UNITED STATES PATENT AND TRADEMARK OFFICE

APPLICATION NO.	FILING DATE	FIRST NAMED INVENTOR	ATTORNEY DOCKET NO.	CONFIRMATION NO.
10/532,192	04/21/2005	Walter Link	026032-4887	8765
26371 7590 12/10/2007 FOLEY & LARDNER LLP 777 EAST WISCONSIN AVENUE MILWAUKEE, WI 53202-5306			EXAMINER WILSON, KAITLIN A	
			ART UNIT 3636	PAPER NUMBER
			MAIL DATE 12/10/2007	DELIVERY MODE PAPER

Office Action Summary	Application No.	Applicant(s)	
	10/532,192	LINK, WALTER	
	Examiner	Art Unit	
	Kaitlin A. Wilson	3636

FIG-1

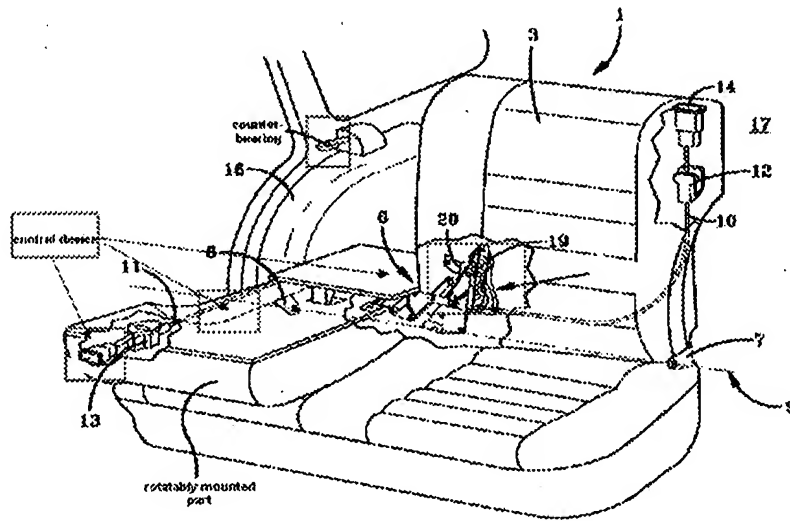
7. In re Claim 1, with reference to Figures 1 and 5, Leuchtmann et al. disclose a device for limiting the movement (12) of rotatably mounted parts (4), in particular pivotable upholstery elements of vehicle seats (1), having a locking piece (22) which is arranged inside the rotatably mounted part (4) and can be made to releasably engage with a counter-bearing (50), characterized in that the locking piece (22) operatively

interacts with a control device (10,15,5) situated in the area of the joint (12) of the rotatably mounted part (3).

8. The examiner notes that that bore through which the bolt (22) travels is considered to be equivalent to the applicant's recitation of "the joint".

9. In re Claim 2, with reference to Figure 1, Leuchtmann et al. disclose that the operative interaction occurs by way of a mechanical force-transmitting device (10). The use of the Bowden cable to transmit a force from the operation of the upper lock to another location on the seat, reads on the applicant's "operative interaction".

14. In re Claim 7, with reference to Figure 1, Leuchtmann et al. disclose that the counter-bearing (15, 50) acts as limit stop in one direction of rotation of the rotatably mounted part (4), and as releasable catch device (51,54) in the opposite direction of rotation (col. 6, lines 23-28).

FIG-5

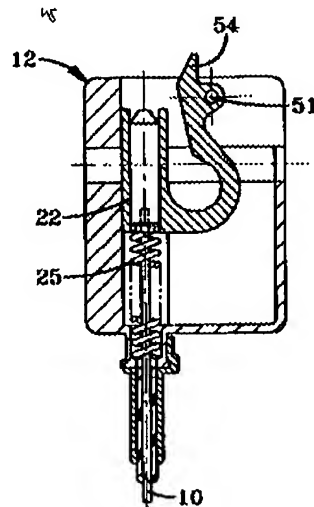
10. In re Claim 3, with reference to Figure 5, Leuchtmann et al. disclose that the locking piece (22) comprises a bolt (22, col. 6, lines 24-29) which is preferably (Figure 5) longitudinally displaceable in the rotatably mounted part (4).

11. In re Claim 4, with reference to Figure 5, Leuchtmann et al. disclose that the bolt (22) has an inclined and/or arched end ace.

12. In re Claim 5, with reference to Figure 5, Leuchtmann et al. disclose that the bolt (22) is configured to be pushed into the part against action of a compression spring (25, col. 6, lines 27-35).

FIG-3

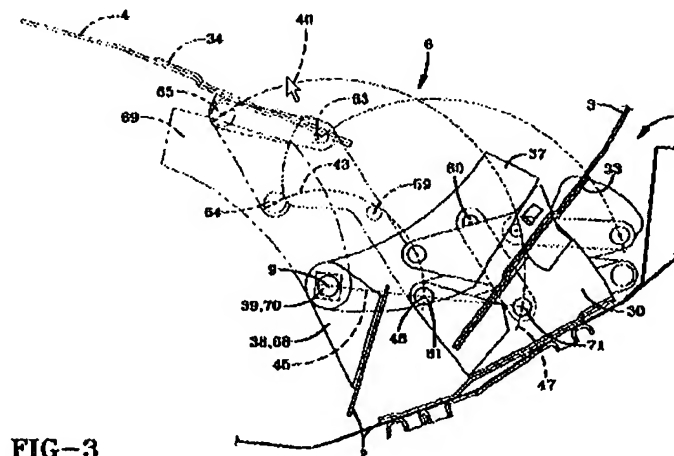
13. In re Claim 6, with reference to Figure 3, Leuchtmann et al. disclose that the control device (10,15,5) has mechanical guide means (5) in relation to which the rotatably mounted part (4) is angularly adjustable.
